SERVICETEKNOTES

TEKTRONIX ANNOUNCES A NEW GENERATION OF DIGITAL
ANALYSIS TOOLS AA
TEKTRONIX DELTA SERIES VLSI TEST SYSTEMS BB
NEW TEKTRONIX VLSI TEST SYSTEM CUTS COST OF IC PRODUCTION
TABLE OF CONTENTS
MODIFY DIP CLIPS FOR USE ON DENSELY POPULATED BOARDS1
CG5001/CG551AP RANDOM SELF-TEST MODIFICATION CORRECTION
DAS 9100 SERIES, INSULATION ADDED UNDER A31L126 AND A31L1272
DC5010/DC510 RISETIME MEASUREMENT IMPROVEMENT
PS5010 LOAD RESISTOR TEKTRONIX P/N CHANGE
S3200/1800 15V TABLE SUPPLY REPLACEMENT KIT
S3200/1800 DC SUBSYSTEM LOGIC BOARD
S3200/R1340/R1341 TRANSISTOR REPLACEMENT KIT
MODIFICATION M#597006
S3200/S3032 WAVEFORM DIGITIZER GROUND STRAPPING
S3200: STATIC ELECTRICITY PRECAUTIONS FOR
IMPROVED RELIABILITY7
SC50X INCORRECT DANGER LABELS8
TDC1/TDC2 NEW DIAL TAPE ASSEMBLY
TSG170A FAN MOUNTING BRACKET CHANGE9
TSG5/TSG15/TSG25 CAL PROCEDURE CHANGE (see Pullout A)
110-S INFO CARDS UPDATED9

CG5001/CG551AP RANDOM SELF-TEST MODIFICATION CORRECTION

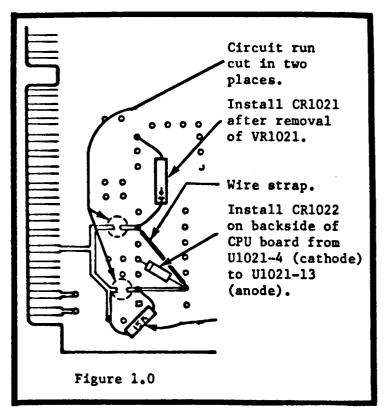
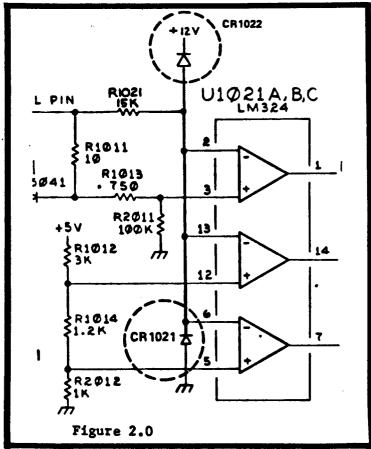
When this modification is installed, using Zener diode Tektronix P/N 152-0175-00, an operator discrepancy is noted. The discrepancy appears when the Pulse Head is not installed on the CG. The operator is able to program the Fast Edge Mode from the front panel without receiving an "Entry Error" message. Also, when the Pulse Head is attached to a powered-up CG it is not being sensed, therefore

To correct this, remove VR1021 and P/N (Tektronix install CR1021 152-0141-02) in its place. Also install CR1022 (Tektronix P/N 152-0141-02) on the backside of CPU U1021-4 board from (cathode) to U1021-13 (anode). Figure 1.0 shows the parts orientation on the backside of the CPU board. Figure 2.0 indicates the schematic changes.

S3200/1800 DC Subsystem Logic Board - see "D.C. Subsystem Logic Parts Location Schematic" on next page

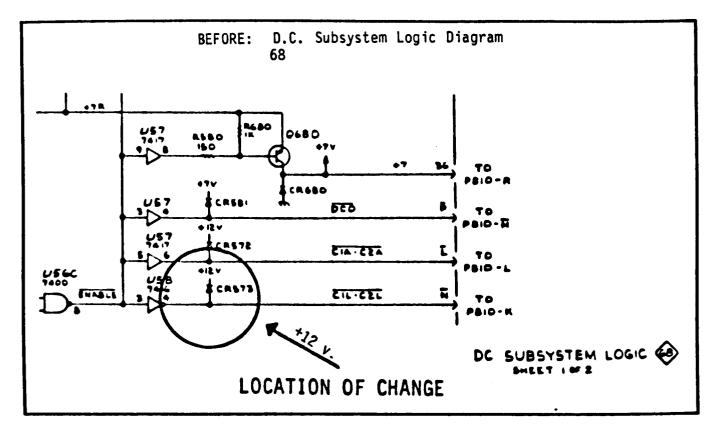
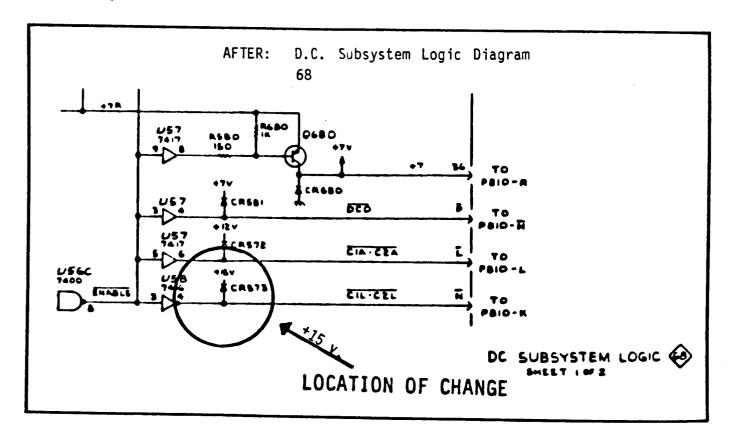
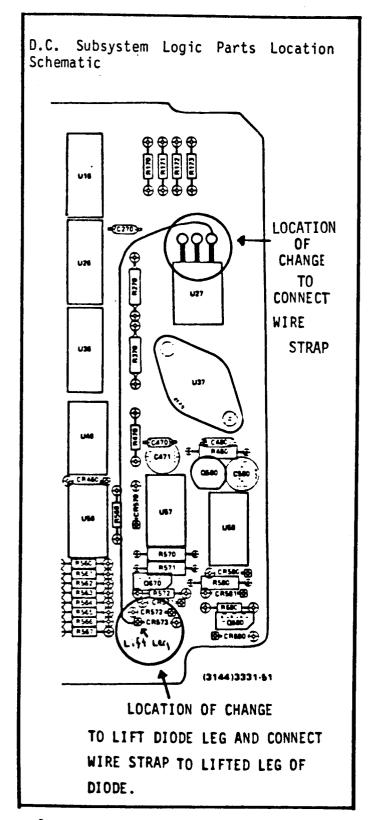
To avoid possible erroneous D.C. Subsystem readings caused by reeds C1L and C21 (K110 & K120 located on the D.C. Subsystem Amplifier board) remaining closed after a "SETUP TO MEASURE (VOLTAGE or CURRENT)" state-

ment has been made, the following modification to the D.C. Subsystem Logic board is recommended:

- 1. Lift the cathode lead end of the diode CR573 (P/N 152-0141-02) located on the D.C. Subsystem Logic Board A28 (see component location schematic).
- Connect the cathode end of the diode to the input side of voltage regulator U27 (P/N 156-0285-00) with approximately 5" of 30 AWG green wire strap. This will replace the +12V reed bias supply with the correct +15v supply.

Installation of this modification requires a change in the D.C. Subsystem Logic board part number from 670-2828-04 to 670-2828-05.

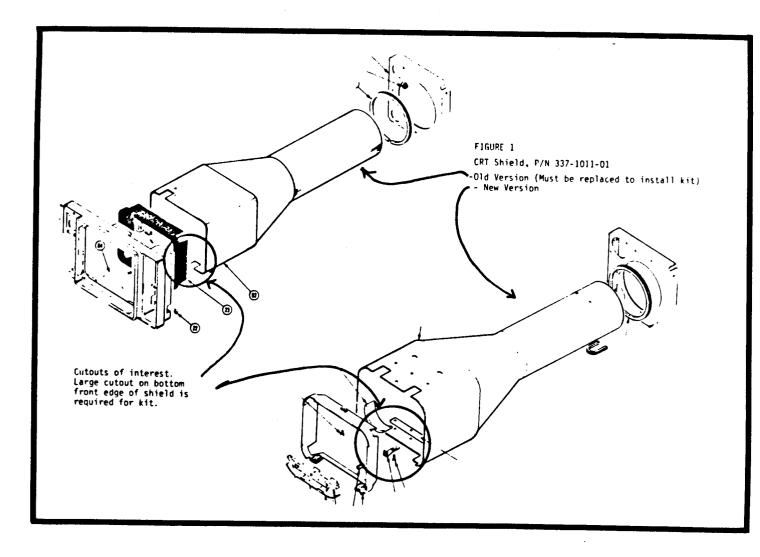
The 528's can now be, at the customer's option, retrofitted with an internal graticule, complete with an improved graticule illumination system for NTSC or PAL applications. The optimum time for considering whether or not to install this feature will be when the CRT requires replacement.

A Parts Notice will be written for early versions, requiring visual identification of the shape and size of the cutout in the CRT shield that accommodates the lower graticule lamps. A large cutout is required for the Grat Lites in the kit. If a small cutout is present, the CRT shield will require replacement. See Figure 1.

1750 L.Y. LOAD

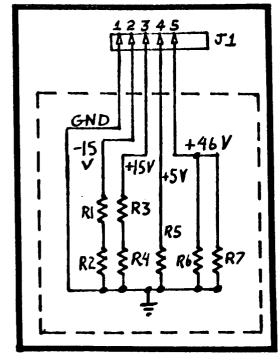
The Schematic shown below provides a load for the supplies that should approximate the maximum expected current draw from a 1750 Series Low Volt power supply.

- An additional resistor is required, so a set of holes drilled in the angle brackets is necessary.
- A different cable and connector are required. Suggested parts are listed with the schematic (above).
- Delete items #1, 2, 3, 7, 8, 9, 10
 and 12.

DIAGRAM (10) PEAK DETECTORS & CCD/CLOCK DRIVERS

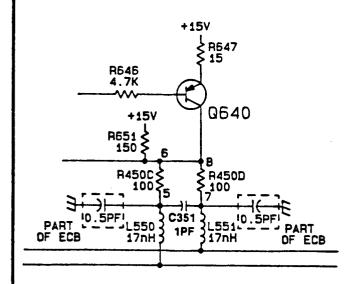
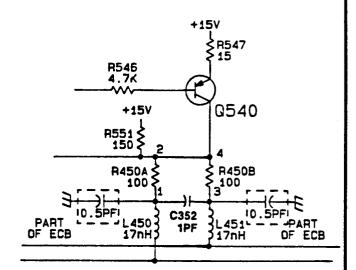
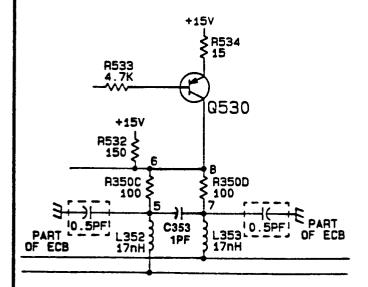
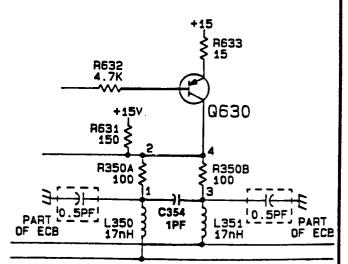
Add 1 pF capacitors C351, C352, C353, and C354 as shown below.

Change the above capacitors, C351, C352, C353, and C354, to 0.5 pF capacitors.
